RPAC St Catherine's School

S96 Access Report

Level 1 96A100 B

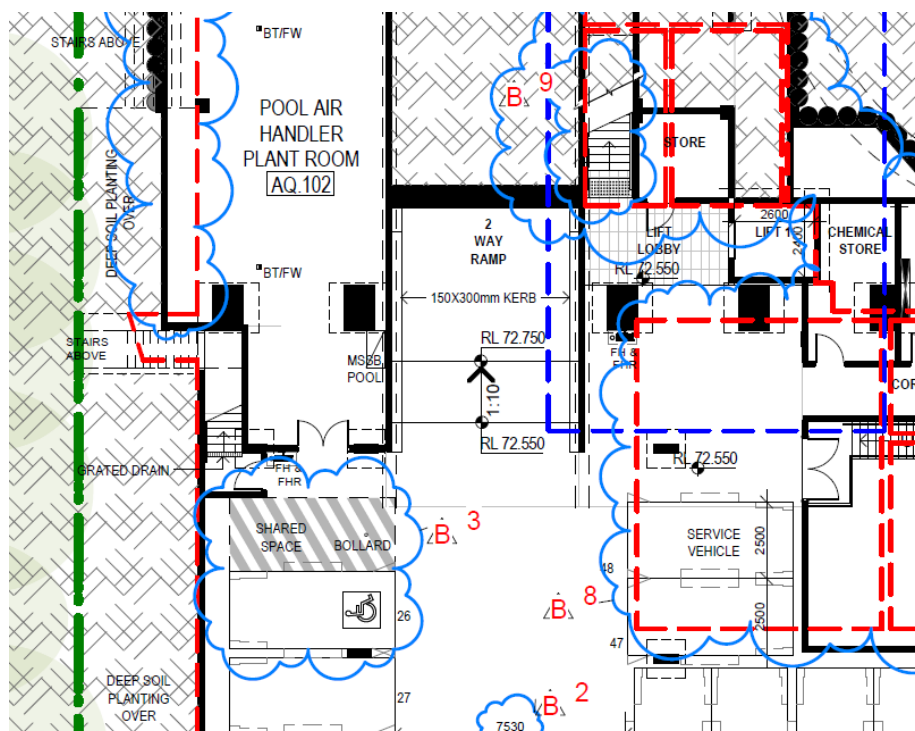
1. CHANGE TO CARPARK RL FROM RL 73.100 TO 72.550 TO ALLOW FOR MINIMUM CLEAR HEIGHTS FOR ACCESIBLE PARKING, POOL STRUCTURE & SERVICES.
3. RELOCATION OF ACCESIBLE CARPARK TO BE CLOSER TO LIFT.
11. CHANGE TO EXISTING PARKING RL TO ALLOW FOR MINIMUM ENTRY HEIGHT CLEARANCE OF 2200mm AFFL. TO EXISTING AND NEW PARKING AREAS.

Relocation of accessible parking

Level 1	Access criteria APS, BCA & Standards
Path of travel (POT) Entries, signage & doors	Provide accessible POTs between carpark and main entrances, consistent signage, and minimum 850 doors with complying nibs and circulation
Stairs, ramps, bollards	Stairs, ramps and walkways to comply with AS1428.1-2009. Provide complying kerb ramps and bollards with minimum 30% luminance contrast between bollards and background Automatic entry doors to include continuous decals 75mm± and 900 to 1000mm high with minimum 30% luminance contrast between decals and background
Accessible parking	Provide accessible parking complying with the BCA and AS2890.6-2009 including minimum 2.4m wide accessible parking spaces with adjacent 2.4m wide shared spaces Provide maximum 1:40 cross fall, minimum 2.2m driveway height, minimum 2.5m parking space height. Install ISA (International Symbol of Access) ground and vertical signage and accessible POT

Signage	Install consistent and accessible identifying signage to each parking level with minimum 30% luminance contrast between signage and background
Passenger lifts	Passenger lifts to provide complying circulation space, minimum 900 wide door and 1400 x 1600 car size, Braille & tactile controls 990 to 1200 high, handrails and audio announcements

Level 2 96A101 B

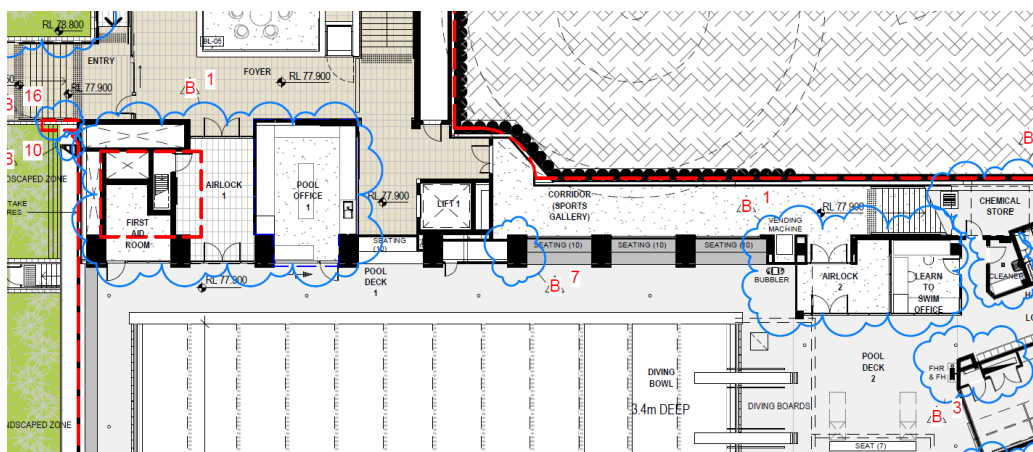
1. LOCATION OF POOL OFFICE CHANGED. THE POOL OFFICE INDICATED IN DA HAS BEEN DIVIDED IN TWO OFFICES, ONE FOR THE MAIN POOL AND ONE FOR THE LEARN TO SWIM POOL. A FIRST AID ROOM AND AIR LOCKS HAVE BEEN INTRODUCED FOR SAFETY AND AMENITY. STAIR CONFIGURATION REVISED.

Pool office & learn to swim office

Level 2	Access criteria APS, BCA & Standards
Path of travel (POT) Entries, signage & doors Stairs, ramps, bollards, passenger lifts & signage	Comply with Level 1 access criteria
Seating	<i>Recommendation – provide minimum 20% seating with backs and armrests, and adjacent wheelchair seating spaces</i>
Ramps & stairs	Install tactile indicators to all ramps & stairs with closed risers, complying handrails, kerbs etc
Amenities	Provide complying unisex accessible toilets and showers Install PAD cubicles in gender specific toilets (to assist persons with ambulant disabilities)
Counters	<i>Recommendation – provide minimum 1m wide accessible counter section 850 ±20 high</i>
Pool access	Provide complying accessible water entry / exit for swimming pools

Level 3 96A102 B

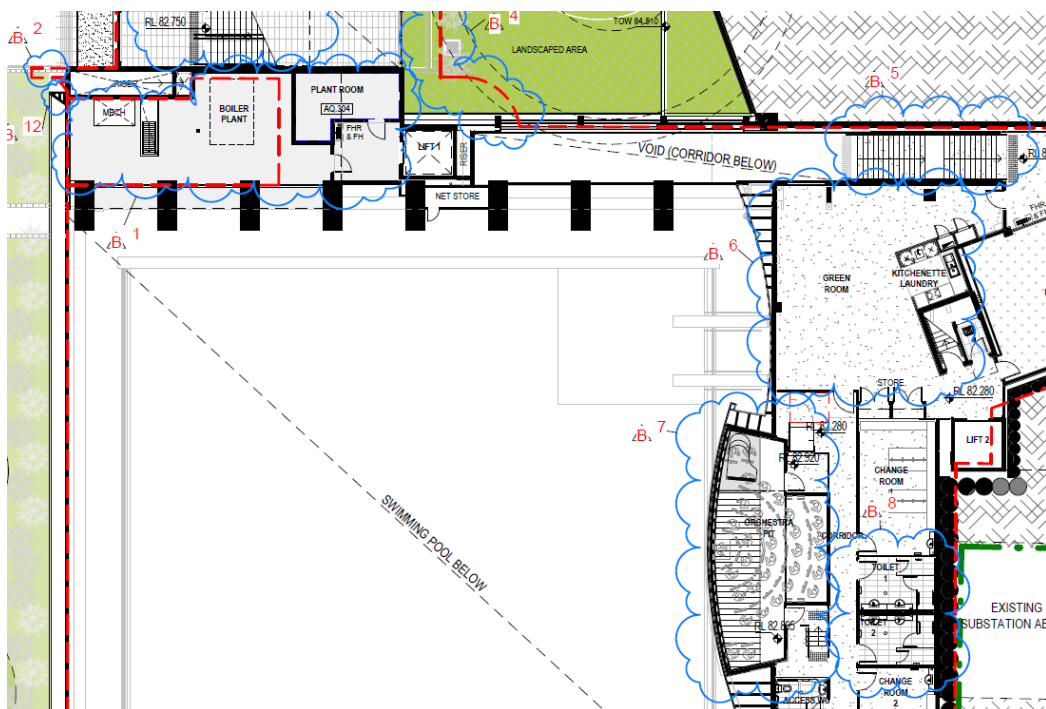
1. EXTENT OF PLANT ROOM AMENDED AND ACCESS PROVIDED VIA LIFT AND NEW STAIR.
5. GEOMETRY OF STAIR AMENDED.
6. SIZE OF GREEN ROOM ENLARGED DUE TO STRUCTURAL REQUIREMENTS. GREEN ROOM TO INCLUDE NEW KITCHENETTE AND STORAGE CUPBOARDS.
7. GEOMETRY OF ORCHESTRA PIT REDEFINED.
8. TOILET LAYOUTS AMENDED.

Lift, stairs and amenities

Level 3	Access criteria APS, BCA & Standards
Path of travel (POT) Entries, signage & doors Stairs, ramps, bollards, passenger lifts & signage Amenities	Comply with Level 1 access criteria Provide complying unisex accessible toilets and showers Install PAD cubicles in gender specific toilets (to assist persons with ambulant disabilities)

Foyer and terrace

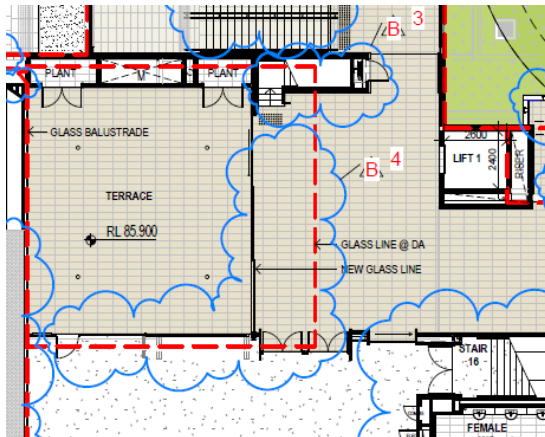
5. STEPS BETWEEN FOYER AND TERRACE DELETED TO PROVIDE A LEVEL CONNECTION BETWEEN BOTH AREAS.

Level 4	Access criteria APS, BCA & Standards
Path of travel (POT) Entries, signage & doors Stairs, ramps, bollards, passenger lifts & signage	Comply with Level 1 access criteria Provide level junctions between new and existing paving
Amenities	Install complying PAD cubicles and adjacent accessible toilet
Auditorium	Provide complying wheelchair seating spaces with adjacent companion seats Provide equitable access to the stage
Counters	<i>Recommendation – provide minimum 1m wide accessible counter section 850 ±20 high</i>
Platform lift	Passenger platform lift to provide complying circulation space, minimum 900 wide door, 1100 x 1400 car size, Braille & tactile controls 990 to 1200 high, handrails and audio announcements Platform lift controls to be momentary pressure and usable without a key during normal school operation hours

Platform lift

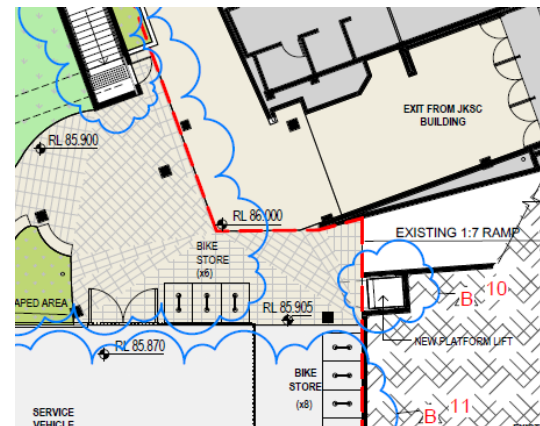
10. NEW PLATFORM LIFT TO PROVIDE DISABLED ACCESS BETWEEN LEVEL 4 AND EXISTING PLAYGROUND AREA ABOVE.

Board Room

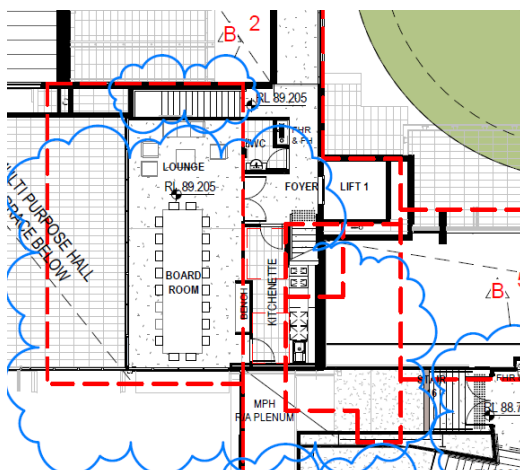
3. BOARDROOM SIZE REDUCED AND LAYOUT AMENDED. NEW KITCHENETTE INCLUDED. BATHROOM RE-LOCATED. STORE DELETED, STAIR ORIENTATION AMENDED.
8. NEW PLATFORM LIFT TO PROVIDE DISABLE ACCESS BETWEEN LEVEL 4 AND EXISTING PLAYGROUND AREA.

Level 5	Access criteria APS, BCA & Standards
Path of travel (POT) Entries, signage & doors Stairs, ramps, bollards, passenger lifts & signage	Comply with Level 1 access criteria
Kitchenette	<i>Recommendation – provide minimum 1m wide accessible counter section 850 ±20 high</i>
Platform lift	Refer Level 4 criteria

Auditorium

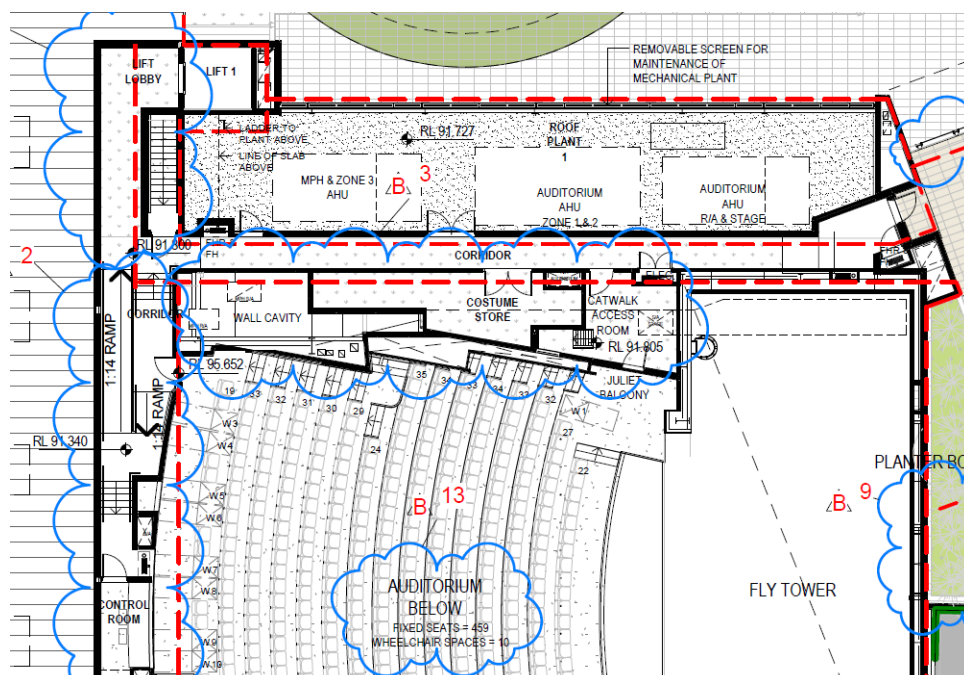
2. - AREA INCREASE DUE TO ACCESSIBILITY CIRCULATION ARRANGEMENTS.
- LAYOUT MODIFICATION TO AUDITORIUM SEATING FOR ADEQUATE SIGHT LINES TO STAGE.
6. NEW LIFT LOCATION FOR STRUCTURAL REASONS.
7. FLOOR LAYOUT CHANGES TO WET AREAS, SEMINAR ROOMS AND STAFF AREAS.
8. OUTDOOR LEARNING AREA DESIGN TO ADDRESS SCHOOL TEACHING REQUIREMENTS AND TO SAVE FLOOR LEVEL DIFFERENCE BETWEEN EXISTING OUTDOOR AREAS AND NEW RESEARCH CENTRE BUILDING.
13. TOTAL NUMBER OF SEATS REDUCED TO 469 (459 FIXED +10 ACCESSIBLE)

Level 6	Access criteria APS, BCA & Standards
Path of travel (POT) Entries, signage & doors Stairs, ramps, bollards, passenger lifts & signage	Comply with Level 1 access criteria
Auditorium	Refer level 4 criteria
Amenities	Provide complying unisex accessible toilets Install PAD cubicles in gender specific toilets (to assist persons with ambulant disabilities)
